Subject: Recommendations Approval (2012) (AP-91) - Plains 8-Inch Moore To Jal #1 Release Site

RE: Annual Monitoring Report (2012) for the Plains Marketing's 8-Inch Moore To Jal #1 Release Site (AP-91)
Unit Letter F, Section 16, T17S, R37E, NMPM, Lea County, New Mexico Recommendations Approval

Groundwater Monitoring System Plan Amendment Approval (AP-91) - Plains 8-Inch

Subject: Plains Pipeline - Moore to Jal #1 site (AP-91)

Attachments: MJ#1 PMW map April 2013.pdf

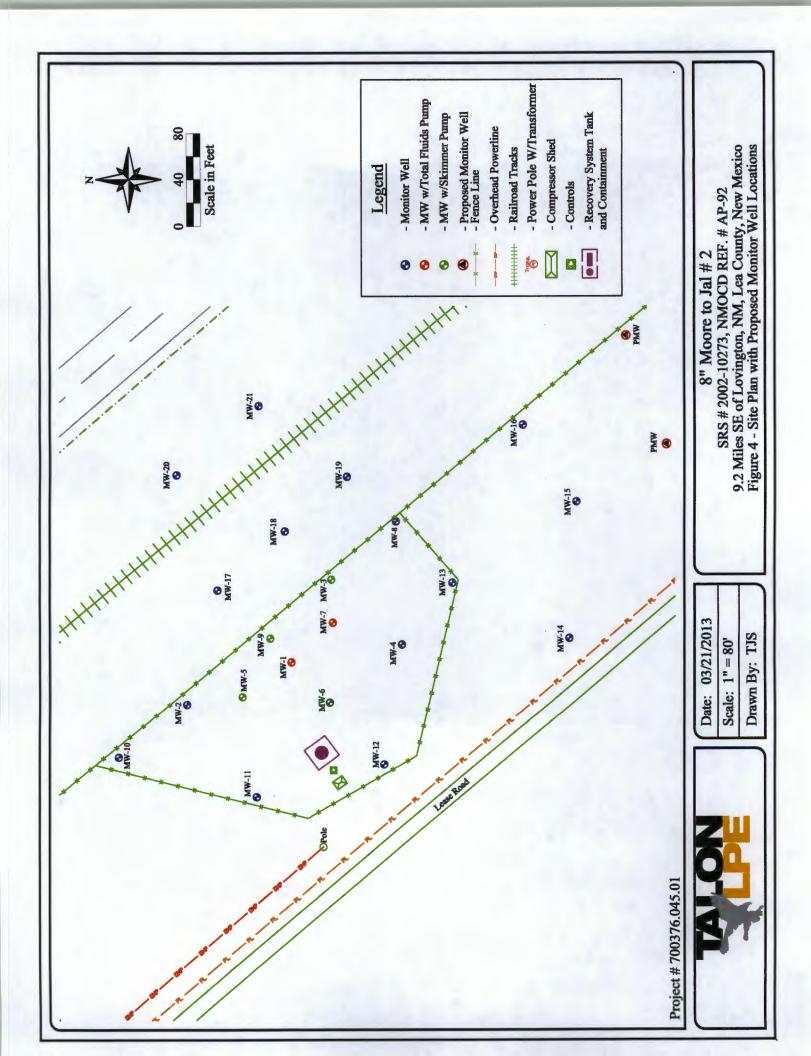
Plains Pipeline respectfully requests NMOCD approval to install 2 additional monitor wells at the above referenced site. Attached is a site map that depicts the approximate locations (PMW) where the 2 additional monitor wells will be installed.

The New Mexico Oil Conservation Division (OCD) has received the Groundwater Monitoring System Plan Amendment for the above-referenced site, dated April 12, 2013, and has conducted a review of the plan amendment. The plan amendment substantially meets the requirements of 19.15.30 NMAC. Therefore, the OCD hereby approves the plan amendment subject to the following condition:

Plains must submit to the OCD an installation report for the two proposed groundwater monitoring wells within 90 days.
